Mini Holland Cycle Scheme

Stage 1 Road Safety Audit

Ref: 2524/032/A105/BOR/2016

London Borough of Enfield

TITLE: PROPOSED A105 ROUTE SHEET 14	
SCALE: NTS	DRAWING NO: B240G001-SK-A105-001-14
REV: E

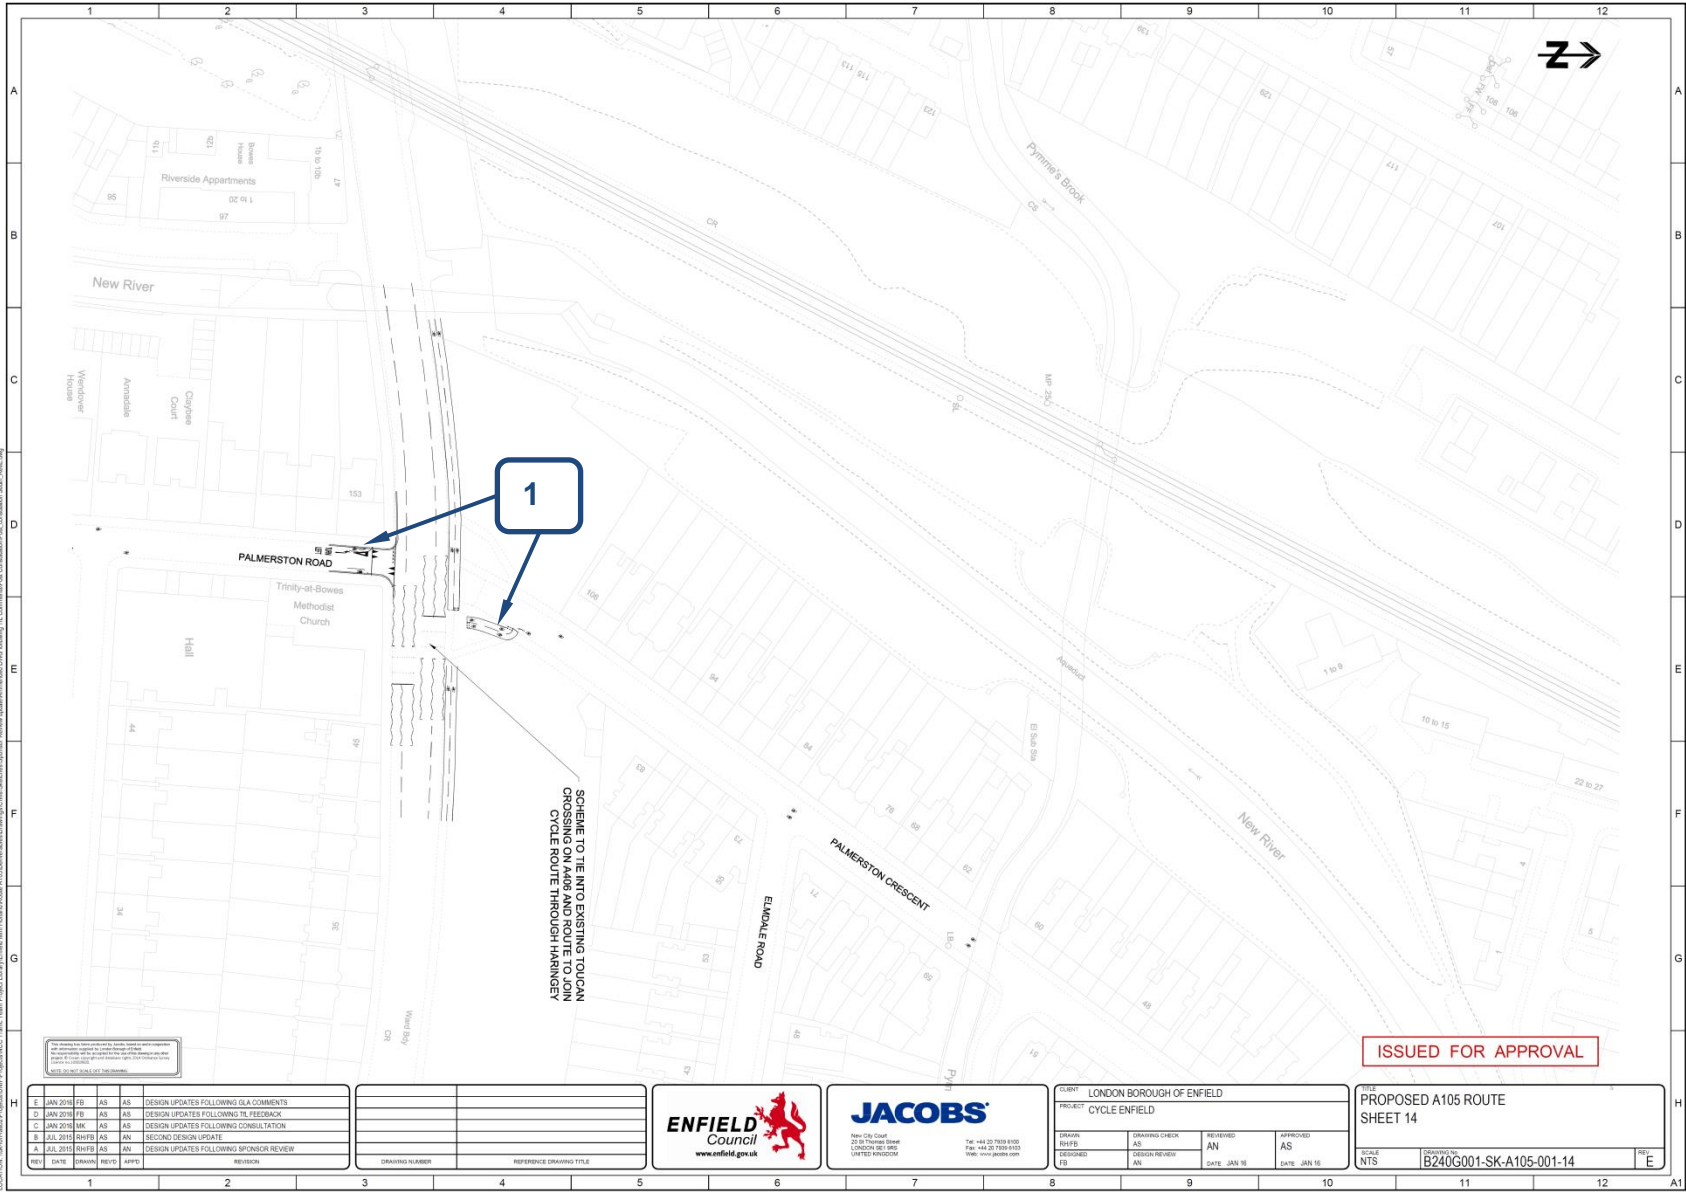
Location: 14 – Drawing 001-14 – Palmerston Road junction with A405

Design Organisation Response	Accepted subject to Detailed Design
<p>North of the A406, the route at the southern end of Palmerston Crescent will be realigned away from the double height kerb. A drop kerb will be provided with a short section of keep clear marking (1026.1) to maintain access for cyclist to the cycle track. The footpath will be widened to allow for a cycle track parallel to the footpath. The exact alignment of the path will be confirmed at detailed design stage following an assessment of the levels.</p> <p>South of the A406 the cycle diverge has been removed, with the existing layout retained.</p> <p>The greenway route, south of the A406 will form part of a separate safety audit.</p>	
Client Organisation Comments	
Designer's response accepted.
